Mount Pleasant Phoenix Place. Ref. 2018/0817/P – LBC Feedback on Revised NMA Drawings and UU – Response Schedule

27.04.18

This schedule has been prepared by DP9 to respond to comments received from London Borough of Camden (LBC) officers on 17.04.18 regarding the revised application submitted 03.04.18 under application ref. 2018/0817/P. It is an update to the response schedule issued to the Council dated 20.04.18 and should supersede that version. It accompanies a final revised set of drawings which have been submitted on 27.04.18 for the Council’s approval under the application. Where updates to proposed drawings have been made in response to LBC officer’s comments, they are cross referenced within this schedule.

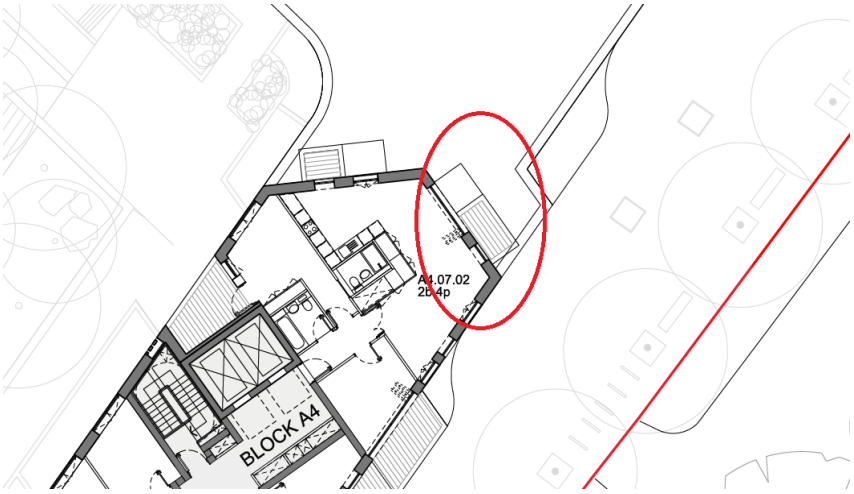
8		The positions of balconies have been relocated in multiple locations (I also mention this in the elevations section below). These all need to be reverted back as	See responses to Points 18 and 19.

approved. I don't recall these changes ever being discussed previously. I haven't marked these up on floor plans but in some of the elevations	
9		Can a red line please be provided on the basement plan (as per the approved plan)?	The basement plan has been updated to include a red line as per the approved plan. Please refer to drawing: 32875-P-03-B00 Rev. P03
10		Extra glazing has been introduced to the residential amenity area on level 04. This is a material change, please revert back	The additional glazing is proposed on a small portion of the Mount Pleasant-facing elevation at Level 04, replacing (as consented) a predominately solid elevation which partly faces inwards towards the courtyard of the building. The glazing is proposed to provide improved internal space for the proposed residential amenity area and to subtly improve the appearance of this elevation. The small portion of the building proposed to be glazed is located at the fourth level of a building that in places rises to 15 storeys, and is set back substantially (by over 10m) from the Mount Pleasant elevation frontage, sitting behind the parapet which means the visual impact will be negligible. The Mount Pleasant elevation as a whole includes substantial amounts of glazing as consented and proposed and the limited proposed inclusion of additional glazing in this location is not considered to materially affect the appearance of the building. No overlooking issues are raised as a result of the additional glazing. For the reasons outlined above the proposed amendment does not result in the development becoming contrary to planning policies or impact upon important material considerations made in the determination of the application and is therefore considered a non-material amendment to the consented scheme. Please refer to drawings: 32875-P-03-004 Rev. P02 and 32875-05-003 Rev. P04

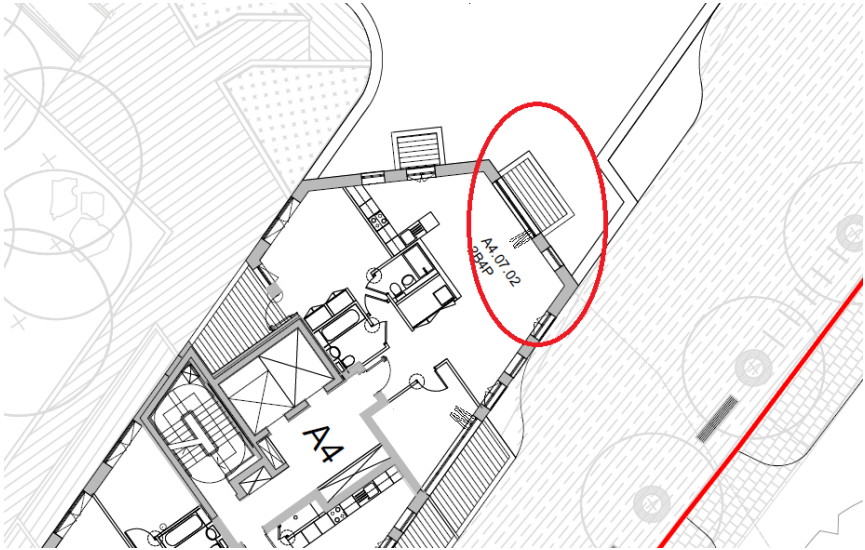
11		<p>Creation of community amenity space on level 06 – this was removed after I advised it was material change at pre-app stage, it was not on the first formally submitted plans and has now returned. Please remove as previously agreed</p>	<p>We do not agree that this is a material change as it does not give rise to any additional considerations. Notwithstanding, we have removed the annotation of “Communal Amenity Space” for the roof next to the amenity area on Level 06. This area is accessible for maintenance only.</p> <p>Please refer to drawing: 32875-P-03-006 Rev.P03</p>
12		<p>Communal amenity space annotations have been removed at various places from the approved plans (I’ve marked this up on the plans where possible). These should all revert to as they were originally approved</p>	<p>The approved communal amenity space annotations have been re-added to drawings in all cases with the exception of the communal amenity space at roof level above the proposed location of Core A5 which has been removed for practical reasons. It had been proposed to replace this with new communal amenity space for Core A5 on the roof next to the internal communal amenity area on Level 06 but this element of the proposals has been removed in response to officer’s comments (see response to Point 11). The overall provision of communal amenity space increases marginally as a result of the proposed amendments with additional space provided at roof level on Core A2 for the affordable units accessed from that core. All units within A5 continue to enjoy access to internal and external communal amenity space including internal communal residents’ amenity spaces at Levels 04 and 06, an external community amenity space at roof level accessed from Level 04 and the courtyard. All Cores have access to roof level external amenity space with the exception of Core A4 which is the same as the consented position. The scheme continues to provide good levels of external communal amenity space for all units and this minor amendment is therefore considered non-material.</p>

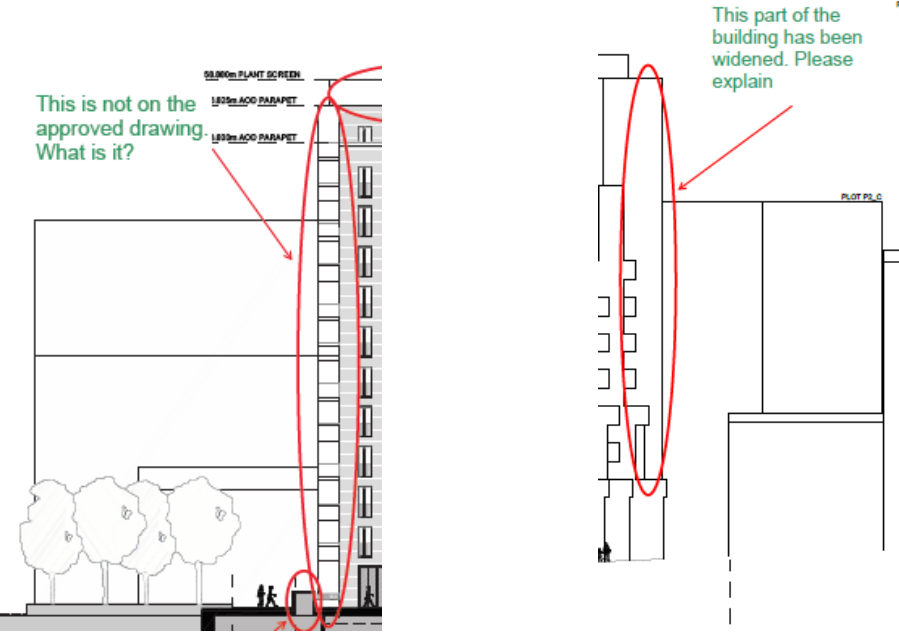
13		<p>Green roof has been removed from level 12, I presume to make way for the plant that you have kept on the drawings. Please revert back to as approved</p>	<p>Consented drawing LL435_MP_(00)_P114 P3 shows the approved locations for green/brown roofs across the scheme. Condition 21 requires full details of the green/brown roofs in the areas shown on that drawing to be submitted for approval. As part of the NMA the Applicant proposed alternative locations for the green/brown roofs and an overall increase in green roofs compared with the consented scheme. Details of the proposed revised locations for green/brown roofs were shown on Proposed Plan 32875 P-03-014-P01. As Condition 21 specifically referred to an approved drawing which showed the green/brown roofs in different locations, it would not be possible to discharge the Condition with the revised proposals as it is currently worded. To</p>

<p>address this, as part of the NMA application it was proposed to amend Condition 21 to allow for details of green/brown roofs to be submitted for Block A (Section P1) in accordance with the arrangement shown on Proposed Plan 32875 P-03-014-P01. LBC Officers have advised that the applicant should apply for the revised green roof locations under the Condition rather than the NMA. To allow this flexibility it is proposed to amend Condition 21 under this NMA application to read as follows:</p> <p><i>“Notwithstanding the approved plans, full details in respect of the green/brown roofs should be submitted to and approved by the Local Planning Authority before the relevant Section of the development commences</i></p> <p><i>The biodiversity (green/brown) roof(s) shall be:</i></p> <ul style="list-style-type: none"> <i>a) biodiversity based with extensive substrate base (depth 80-150mm);</i> <i>b) laid out in accordance with plans hereby approved; and</i> <i>c) planted/seeded with an agreed mix of species within the first planting season following the practical completion of the building works (the seed mix shall be focused on wildflower planting, and shall contain no more than a maximum of 25% sedum).</i> <p><i>The biodiversity (green/brown) roof shall not be used as an amenity or sitting out space of any kind whatsoever and shall only be used in the case of essential maintenance or repair, or escape in case of emergency.</i></p> <p><i>The buildings shall not be occupied until the approved details have been implemented and these works shall be permanently retained and maintained thereafter.</i></p> <p><i>This condition can be discharged on a Section by Section basis.”</i></p> <p>We understand this revised wording is supported in principle by officers as it allows them the flexibility to consider a range of green/brown roof locations. LBC officers have confirmed this wording is acceptable.</p>

Green/brown roof locations have accordingly been removed from the proposed drawings. Please refer to drawing: 32875 P-03-014-Rev. P02
14		There is an infill at upper ground level near the residents lounge that lies adjacent to core A6. This is filling in a jettied overhang area. I've marked it on the plans. This is a material change and should be reverted back to as approved.	<p>The amendment comprises a minor infill at a single (upper ground floor) level on a courtyard facing elevation. This elevation is internal to the scheme and cannot be seen from outside the site boundary. The infill of the jettied overhang area will subtly improve the appearance of the elevation and result in an improved entrance for the residential block.</p> <p>The new entrance arrangement greatly improves accessibility and user experience with improved circulation and usability of internal spaces. From a practical perspective the proposed layout for the concierge improves the security of the development by ensuring that all persons entering the development are seen by the concierge. In the previous scheme people could 'tail-gate' into the courtyard without any secondary layer of security. The other practical benefit is there is a more definitive entrance to help the building function with regards to post, deliveries and visitors.</p> <p>For the reasons outlined above we consider that the proposed amendment does not result in the development becoming contrary to planning policies or impacts upon important material considerations made in the determination of the application and is therefore considered a non-material amendment to the consented scheme.</p> <p>This is illustrated on drawings 32875-P-03-G01 Rev. P03, 32875-05-002 Rev. P04 and 32875-P-05-007 Rev. P04.</p>
